# City of Burlingame

## Meeting Minutes Planning Commission

- b. 1245 Cabrillo Avenue, zoned R-1 - Application for Amendment to Design Review for changes to a previously approved first and second story addition to an existing single family dwelling and new detached garage. This project is Categorically Exempt from the California Environmental Quality Act (CEQA) pursuant to CEQA Guidelines Section 15303 (a). (Eric and Jennifer Lai, applicants and property owners; Chu Design Associates Inc., designer) (113 noticed) Staff Contact: Ruben Hurin

**Exhibit 1: Left Rear Photos**  
**Current vs Proposed 2.8' Wall Extension**  
**Poles and Tarp at proposed 9' 1st Floor Plate Height**

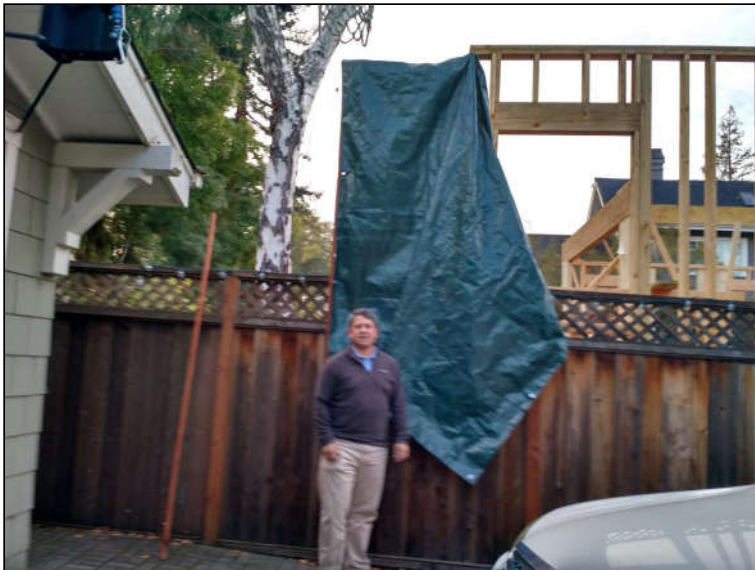
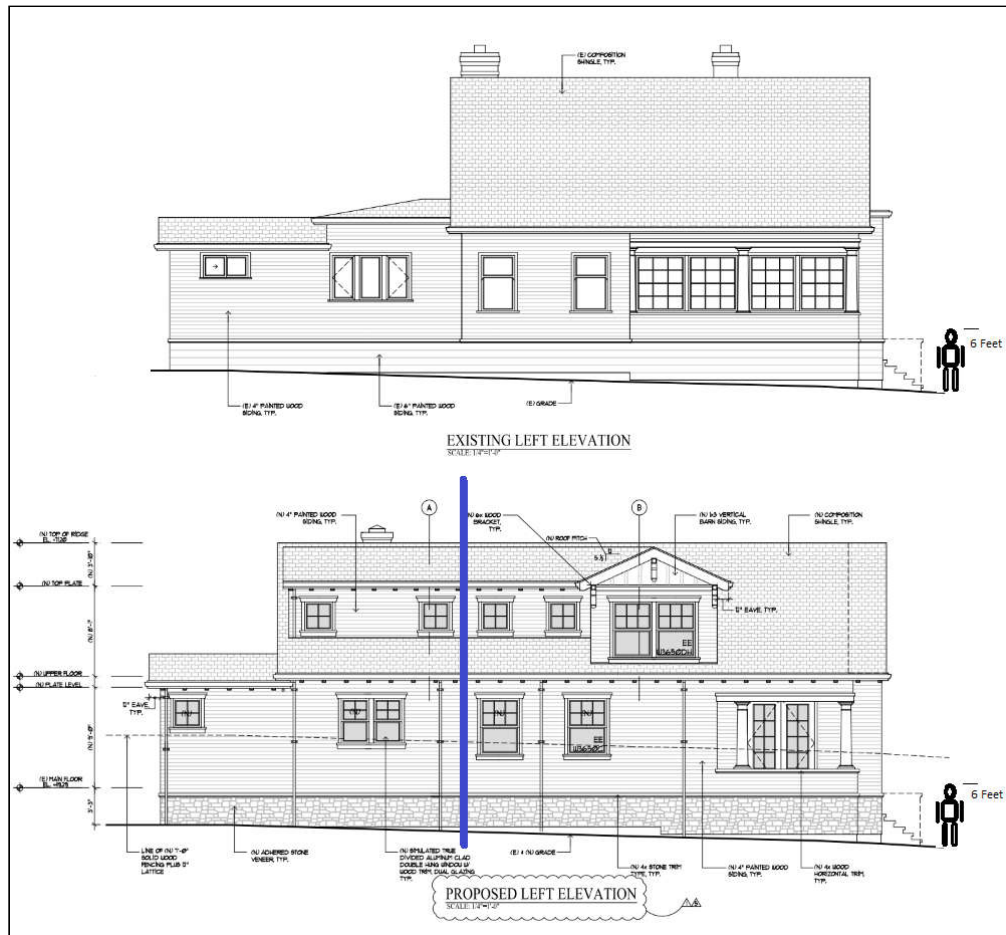
Note: Current wall/window stud is not to edge (short) of current foundation. Poles set at proposed (Jan 14) location and height.

Proposed: ~51' x 12-14' Vertical Rectangle (1st Floor excluding Porch)  
Originally: House had more open Porch (> 50% of main house section), ~4 "sections" to 1st Floor wall, and stepped down in rear to minimize mass and visual impact.

At Blue Line, if 1st Floor left rear wall was moved in 18", and roof pitch steepened to new plate, it would break long run into 2 sections, similar to how original house used differing roof heights and an 18" inset between peaked roof main house and middle addition to break up long run originally. 1st Floor Roof Eve is ~13' above grade at this point.

**Item 1: Left Rear Photos Before & After  
See Top Plate and Roof relative to "Y" in Tree.**

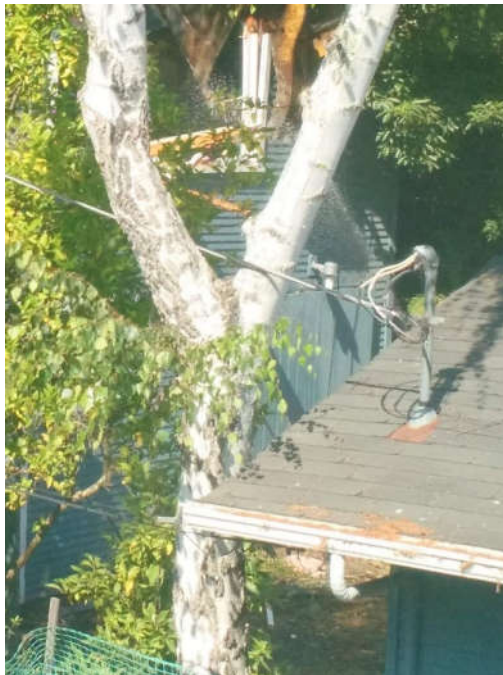
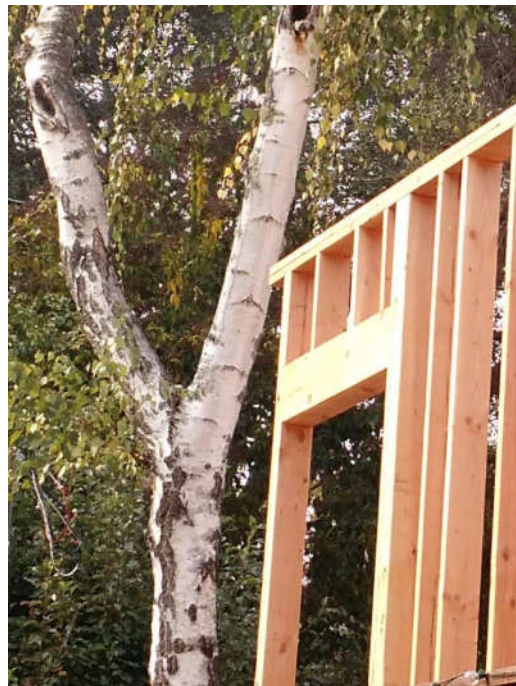
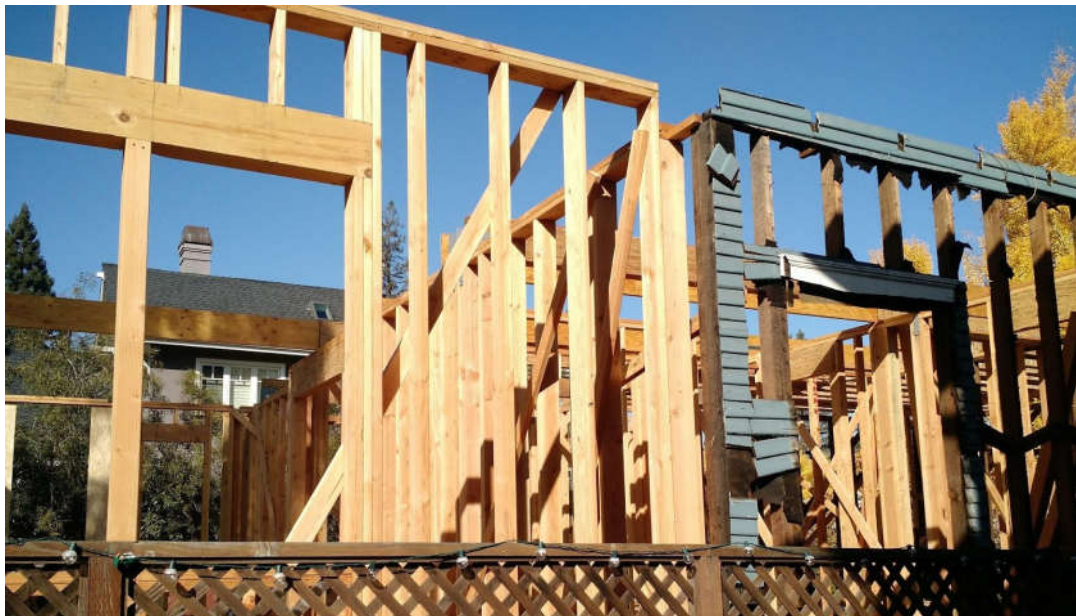
Note: New Wall is 3 1/2 feet taller than before, as measured. Plan says 2 1/2 feet taller

Note: In bottom right photo, the Top Plate on right side lines up with claimed 9'10" top plate in Living Room Ceiling that was indicated as "Existing".

### Example: As Built Front & Rear Left Wall Exceeds Plans

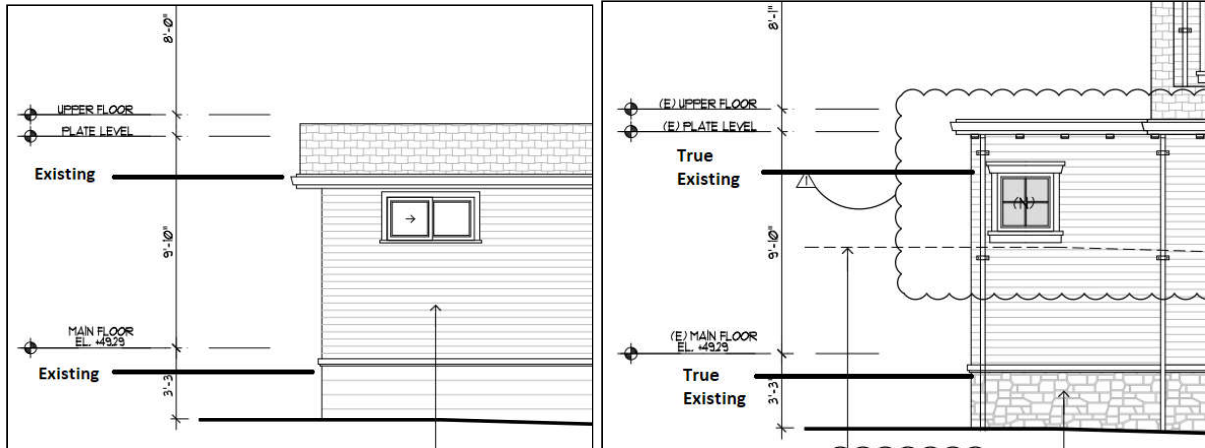
As Built New Rear Wall:  $10.725\text{ft} = \sim 10'\text{-}9''$  As Built vs.  $9'\text{-}10''$  on Plans

New Front Left Wall =  $10'\text{-}1'' + 8'' = 10'\text{-}9''$  As Built

Rebuilt Left Side Walls all exceed Plan Call Out Heights of  $9'\text{-}10''$  by nearly 1 foot extra

### Item 3: Example of Missing / Inaccurate Labels on Plans

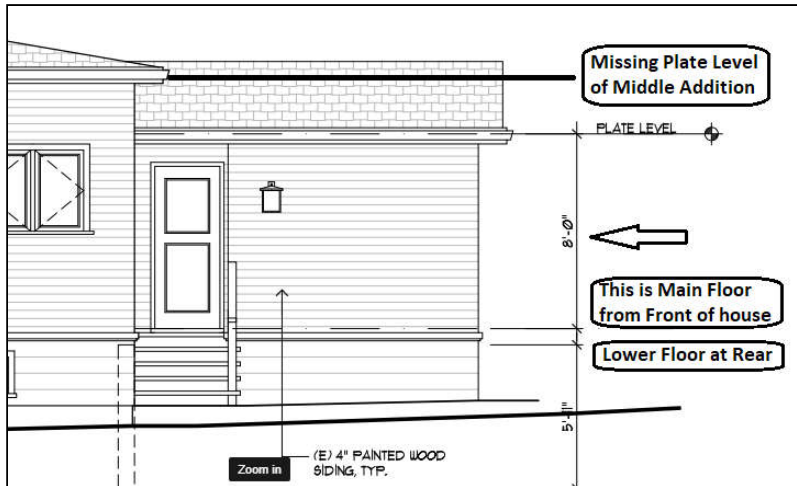
Below from Jan 4 Rev. Missing "Existing" Floor is 2'-7" as shown on Survey, and "Existing" Top Plate is 8'-0" as shown below

Floor Height of Existing SunRoom = 46", or 3'-10", This information is Missing from Plans

Floor of Living Room "Main Floor" Called Out on Plans is 8-10" Higher than Floor of Left Wall

Floor of Cantilevered Bump Out steps up, then stepped down to 2'-7" Surveyed Height at Rear Threshold

## Item 4: Inaccurate Demolition Plans

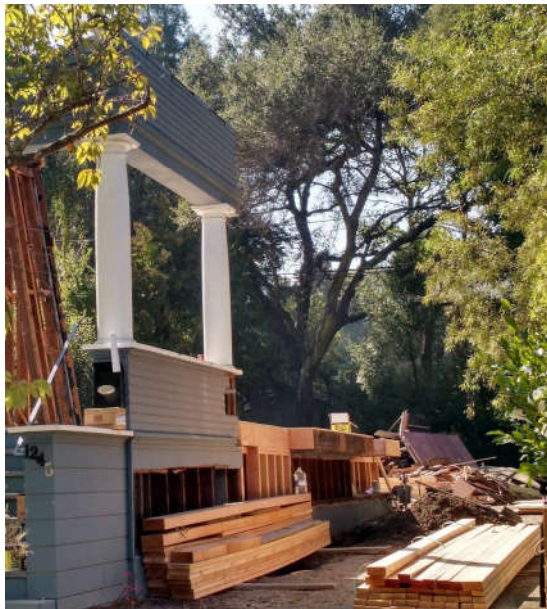
Even current Revised Demolition Plan submitted for this Variance Application is inaccurate.

1. Entire "Existing" Right wall is gone except for open column porch
2. Entire "Existing" Left wall is gone except for cantilever stub wall
3. Entire Rear of Structure is gone
4. All Interior walls are gone, with exception of rear living room wall
5. Including second floor demolition, there is likely less than 16% remaining; see calculation in Exhibit C

Gone - Existing Left Wall, front & rear

## **Item 5: Impact to our Property & Loss of Property Value**

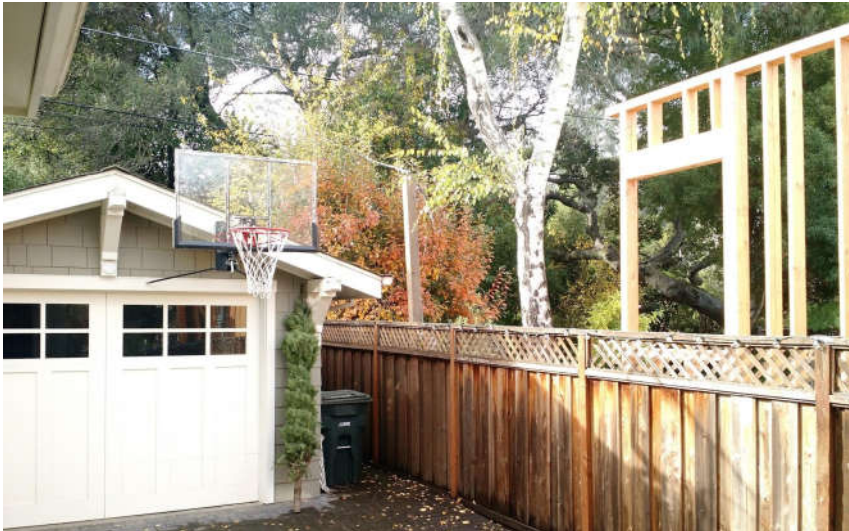
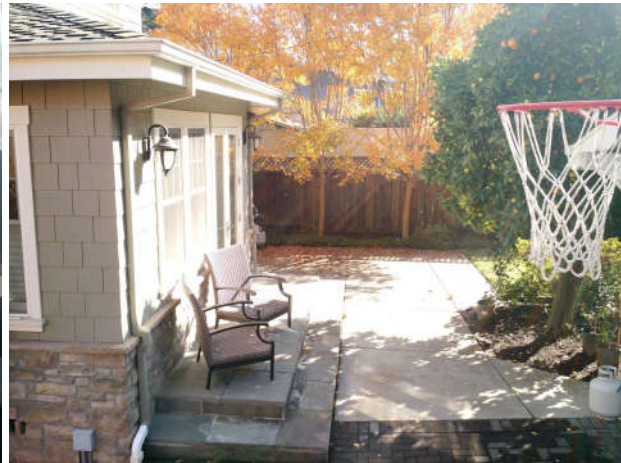
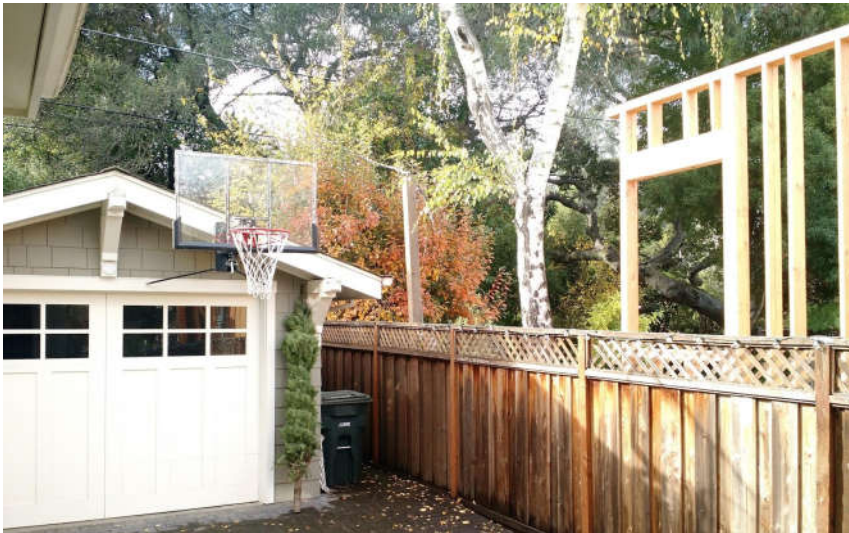
1245 1st floor top plate is 3-4 feet higher than our 2nd Story floor, and even higher than roof of our garage.

All of the windows on their first floor will look through tops of our windows. Similarly, all of the windows on their second floor will look through tops of windows into our bedrooms.

With Nov 29 Rev, they propose extending this wall even further to Tree, and 2nd Story Floor will start just above "paired" 2x4 to right of window opening, creating a continuous, monolithic wall along entire fence line from our garage to the front of their house, with no "open" sun & sky gaps. See Left Elevation, Sheet A5 Nov 29 Rev.

## **Exhibit A1**

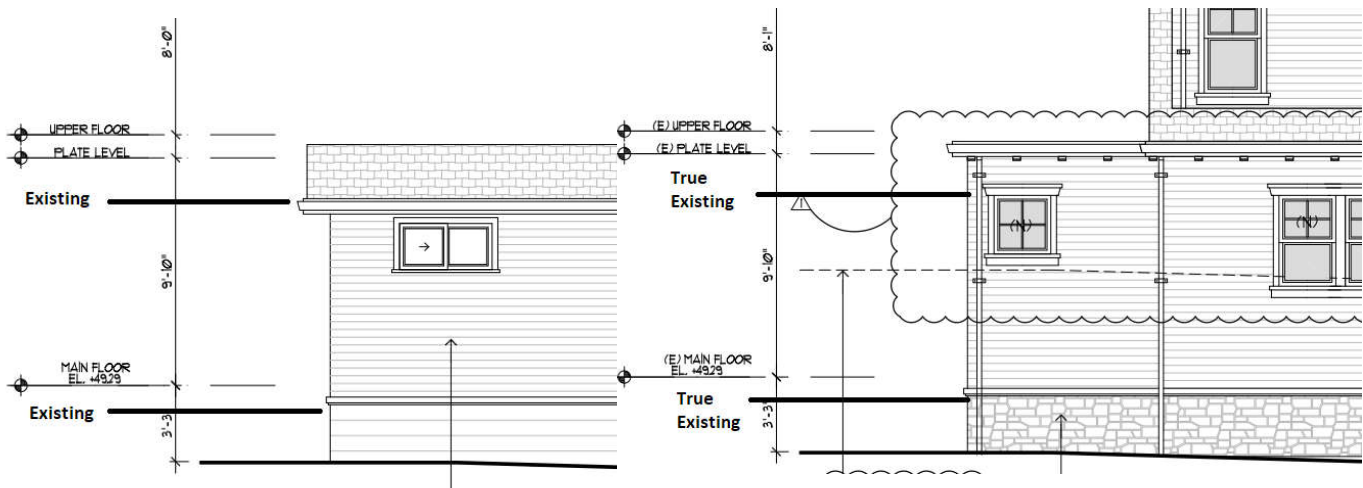
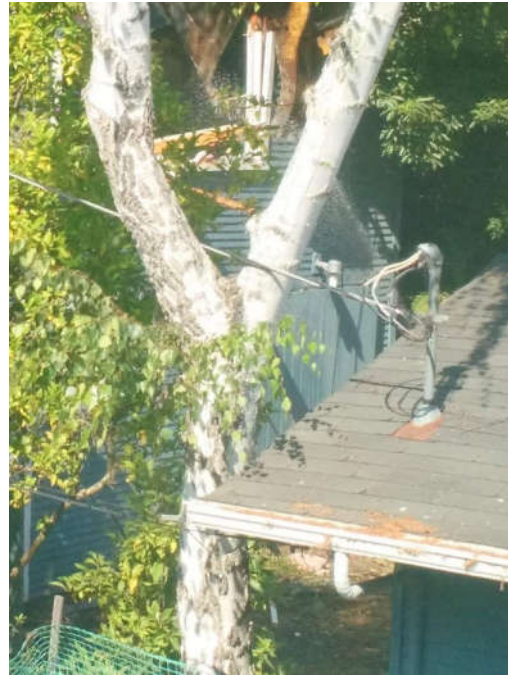
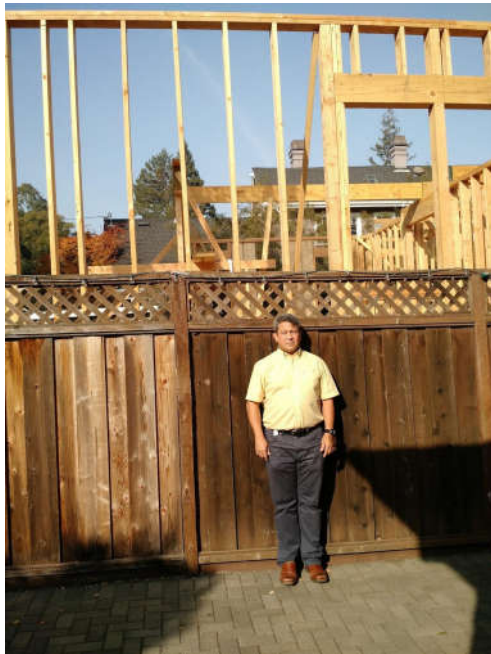
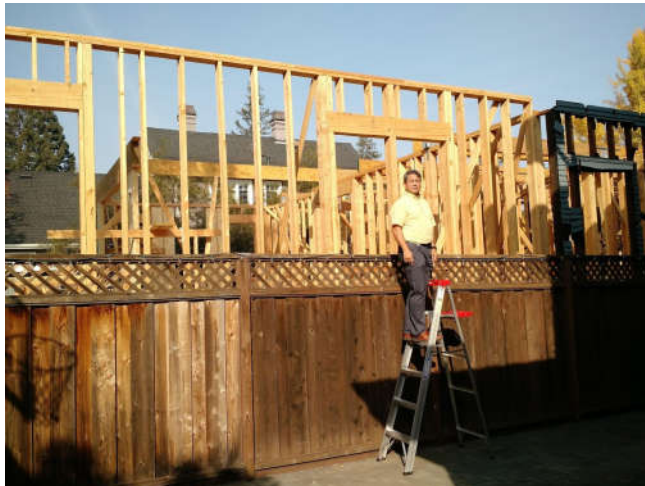
2. The design and plans did not clearly and accurately reflect the floor and ceiling heights of the existing structure.
  - a. The existing structure had 3 different sections to it; evident on the side elevations of existing structure.

- b. From the front of the house to the back, there were several different floor heights as well as top plate heights.
3. The plans that were submitted and "approved" show the "existing" designation in the incorrect spot.

5. The drawings also do not call out the change to existing floor heights.
  - a. The Survey for the Property show Rear Threshold at addition is 8-10" LOWER than Front Threshold (Living Room / "Main Floor")

**"Existing Wall" is now around 3.5 feet higher. Fence is approximately "6+1", actually shorter.**

**Exhibit C**  
**Incorrect Original Demolition Plan**  
**Inaccurate Removal Calculations Still on Revised Plans**  
**This is a NEW House**

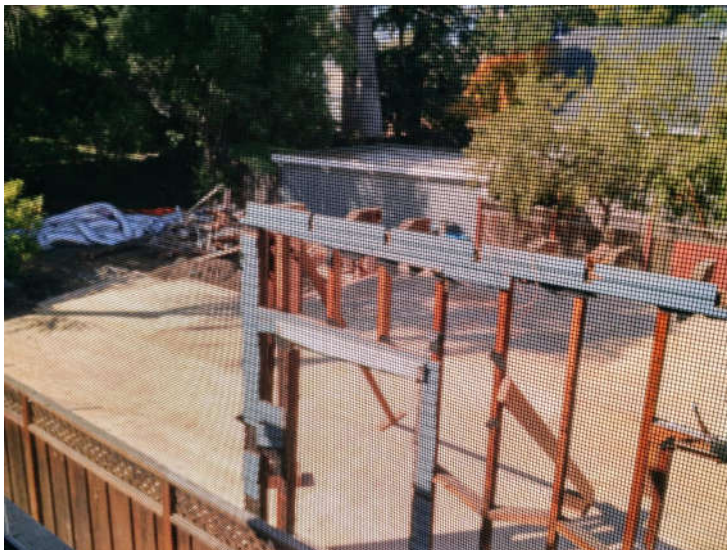
1. The revised (Nov 29 Rev) Demolition Plans are still Inaccurate. See Calculations and Photo Below.
  - a. More than 84% of this house was demolished

- b. That is a kind calculation, not fully counting second floor
2. The January Demo plan for first and second floor led us to believe that majority of structure - exterior walls, roof, etc would remain, and only dormers added, addition updated, and interior walls moved.

5. Jan 4 Rev Demolition Plans claimed less than 50% exterior wall removal primarily at right rear and showed 2nd Floor remaining with just interior wall changes, thereby creating impression majority of structure was remaining, with just new additions and interior wall changes.
